UNITED STATES PATENT AND TRADEMARK OFFICE

APPLICATION NO.	FILING DATE	FIRST NAMED INVENTOR	ATTORNEY DOCKET NO.	CONFIRMATION NO.
10/585,162	06/30/2006	Stefan Morgenstern	5038.1030	8326
23280 7590 10/07/2009 Davidson, Davidson & Kappel, LLC 485 7th Avenue 14th Floor New York, NY 10018				
EXAMINER				
PRAGER, JESSE M				
ART UNIT		PAPER NUMBER		
3745				
MAIL DATE		DELIVERY MODE		
10/07/2009		PAPER

Office Action Summary

DETAILED ACTION

Fig.3.

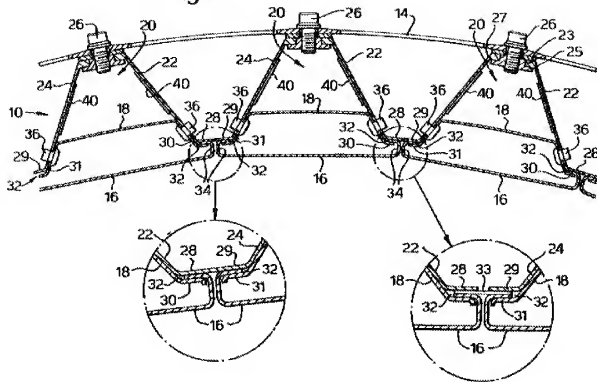
1. Applicant's arguments filed 7/20 have been fully considered but they are not persuasive. Applicant argues that the Hayton reference lacks "each web-like element ... forming a crenelated profile extending in a circumferential direction of the housing", and includes Fig. 4 to show a crenelated profile extending in the axial direction.

Examiner respectively disagrees with the statement "the alleged web-element (22, 24) is not crenelated in the circumferential direction". As stated in the office action, "web elements (22, 24) extend to the first and second plate elements forming a crenelated profile extending in a circumferential direction of the housing." Figure 3 is a cross sectional view showing that the web-elements are crenelated in the circumferential direction.

The crenelated profile is formed by first plate 29 (left) to web element 24, to first plate 23, to web element 22, to second plate elements (28, 29) to web element 24, to first plate 23 to web element 22 to first plate 28. The indented and notched structure makes the profile crenelated in the circumferential direction, and the rejection of claim 11 is maintained since the applicant has not overcome the prima facie case of obviousness.
